Motor Ship "HALLFRIED", No. 72571 in the Register Book.

Overall Dimensions : 375 x 51.25 x 34.12 to upper dk.
25.62 to second deck.

Scantling Numbers : 12797 and 32016

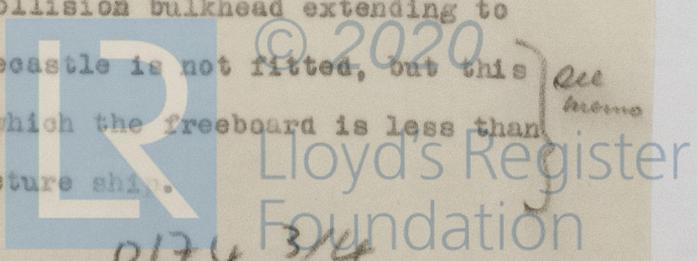
(5) The topside materials are equivalent to the Tables for a flush deck ^{F.S.} ship.

There is no indication on the plans of any concentration of weight amidships.

The upper deck is sheathed all over with 3" pitch pine, and intercostal girders are fitted in line with and in continuation of the hatchway side coamings ⁺ to the sides of the machinery openings.

The Surveyors should pay particular attention to the motor seatings.
